INFCIRC/1084

Communication dated 3 May 2023 received from the Permanent Mission of Japan to the Agency

Japan's Response to the Feedback from the People's Republic of China and the Russian Federation

Figure below shows the layout of the said building.

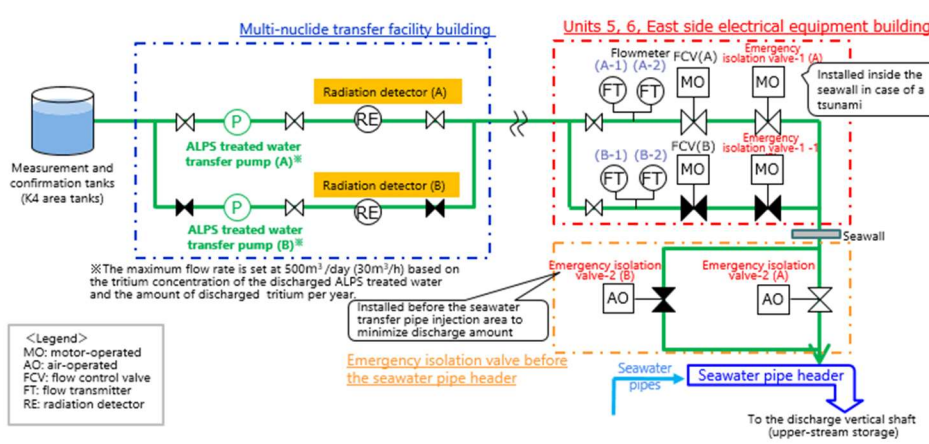
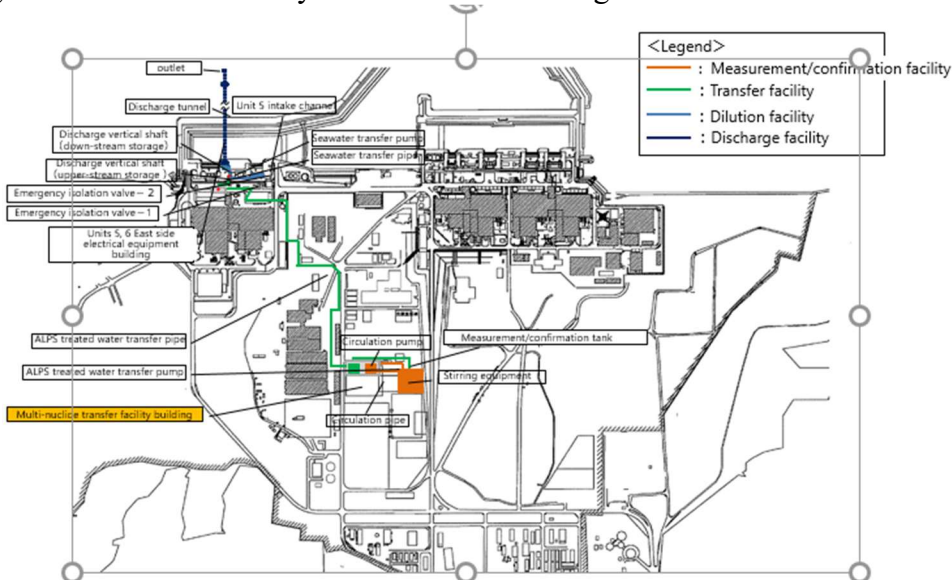
Please specify where the “radiation monitors” are installed and provide details of their performance, in particular the detection limits of radiation. “Online monitoring device” refers to the device used for the real-time dynamic monitoring.

Radiation detectors (radiation monitors) are installed in the multinuclide transfer facility building for the dilution of ALPS treated water (transfer facility). Two figures are provided below. The first figure depicts the location of the radiation detectors in that facility (highlighted in orange). The second figure depicts the location of the Multi-nuclide transfer facility within the building (again, highlighted in orange).
